9 SUB2014-00045

CALGARY SUBDIVISON

CALGARY SUBDIVISION

DETAIL SITE PLAN

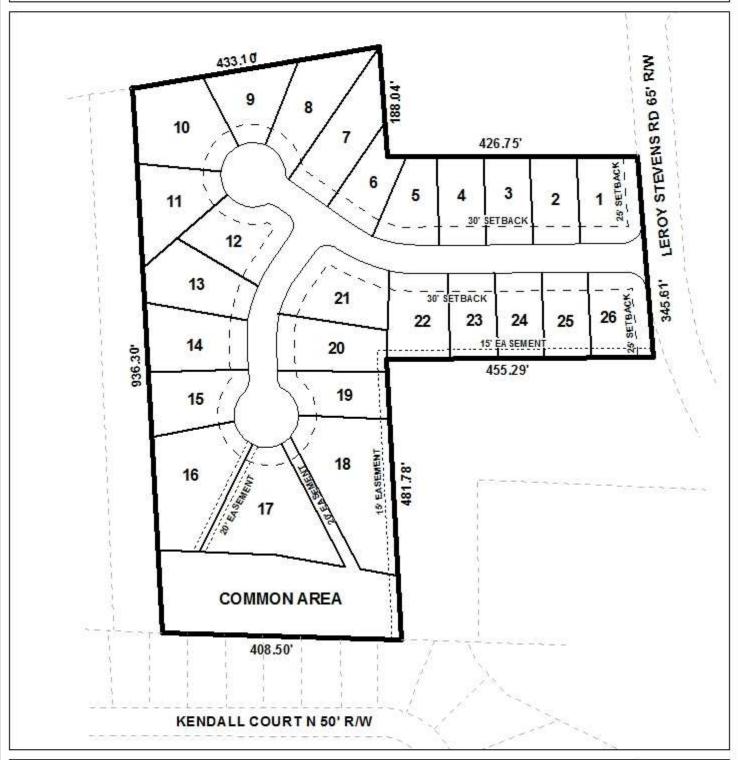
The proposed subdivision fronts Leroy Stevens Road, a minor street without curb and gutter. As the right-of-way is compliant with Section V.B.14. of the Subdivision Regulations, no dedication should be required. The right-of-way width of both proposed streets within the subdivision is 50°, which is also compliant with the above section of the Subdivision Regulations.

As a means of access management, a note should be placed on the Final Plat stating that the proposed Lots 1 and 26 should be denied direct access to Leroy Stevens Road, and that all

proposed lots be limited to 1 curb-cut each to streets within the subdivision, with the size, design and location to be approved by Mobile County Engineering and conform to AASHTO standards.

The preliminary plat illustrates the construction of two new, unnamed streets. It should be pointed out that the cul-de-sacs at the terminus of each street are illustrated with a 55' radius and proposed 110' diameter, instead of 120', as required in Section V.B.14. of the Subdivision Regulations. If approved, the Final Plat should be revised to reflect compliance with the previous section of the Subdivision Regulations regarding turnaround right-of-way diameter.

It should be noted that the site contains numerous easements which are illustrated on the preliminary plat and a $1.24 \pm \text{acre}$ common area, located along the southern lot line of the proposed Lots 16-18 and accessed by a 20' ingress/egress access easement. If approved, notes should be placed on the Final Plat stating that no permanent structures can be constructed in any easement and all common and detention areas shall be maintained by the property owners.

The preliminary plat illustrates a 30' minimum building setback line for all proposed lots within the subdivision, which exceeds the Subdivision Regulations' requirement, and a 25' minimum building setback line along Leroy Stevens Road for the proposed Lots 1 and 26, which meets minimum requirements. Also, all proposed lots appear to exceed the minimum size requirements as the lot size is illustrated in both square feet and acres and should be retained on the Final Plat, adjusted for any required dedication, if approved.

This application is recommended for Holdover until the June 19, 2014 meeting with revisions due by May 23, 2014 to address the following:

1) Inclusion of parcel (R022707362000016.007.) within this request, to include lot and notification fees and labels, if required, or the submission of a notarized letter from the adjacent property owner requesting the exclusion of the parcel from this subdivision.
